BWROG-13014
February 19, 2013

SUBJECT: BWROG ECCS Suction Strainer Program
Closure of Technical Issue 12

Issue No. 12 – Spherical Zone of Influence – Closure Justification

Spherical Zone of Influence

Figure 1: Target Outside Spherical ZOI and Inside Directed Jet

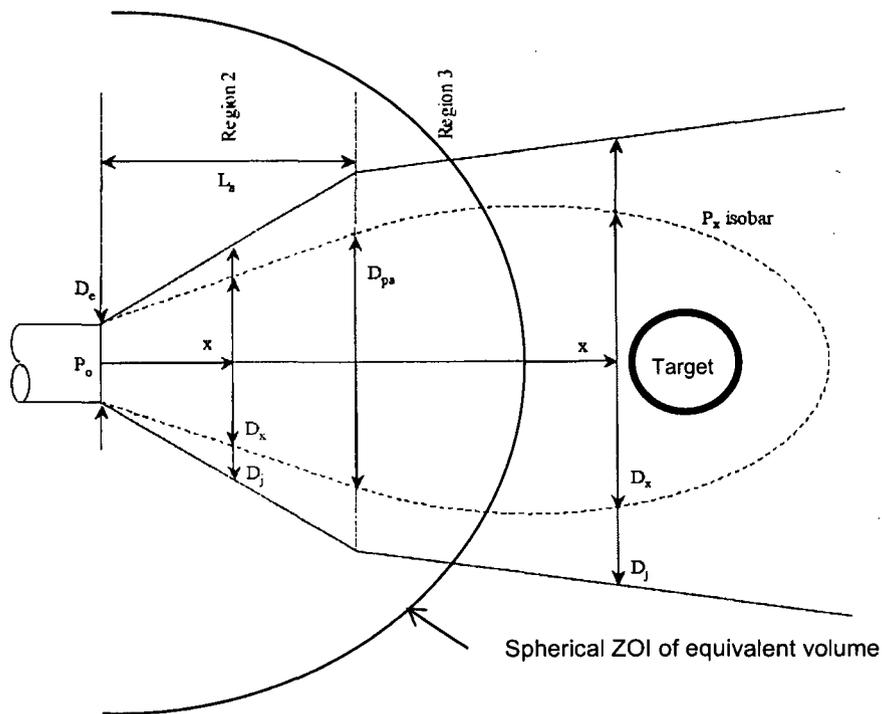
The NRC's concern is that, while a spherical ZOI may have maximized the quantity of debris, it may have precluded selection of a lesser amount of more problematic debris, such as micro-porous or calcium silicate insulation. Such problematic debris materials could be outside the spherical ZOI, but within the ZOI of a directed jet (see Figure 1).

We agree with the NRC staff on the conservatism inherent in the development and application of the spherical ZOI (e.g., reflection, energy dissipation, etc.) and also offer the following additional conservatisms relating to debris sources outside the sphere but within a directed jet:

1. Regarding calcium silicate problematic insulation, the radius of the BWR spherical ZOI is 6.4D (D is expressed in pipe diameter) and larger than the PWR ZOI of 5.45D with higher operating pressures and temperatures.

2. The directed jet theory assumes the break is fully offset with no interference from either the opposing jet or any structures with the effluent hitting a line of site target greater than 24 feet away (12D or 24 feet is the radius of the spherical ZOI associated with Min-K and Microtherm, and assuming a 24 inch pipe break).

While the BWROG understands the NRC staff's concern over these potentially problematic materials, there is no intent by the BWROG to 1) develop new guidance on the size and shape of a directed jet ZOI, or 2) to specifically exclude or ignore problematic debris sources that could, if destroyed, transport to the ECCS suction strainer. The resolution strategy outlined on the BWROG slide 13 mentioned above was prepared in the event the NRC staff chose to revise its position on the acceptability of the spherical ZOI, which they have not.
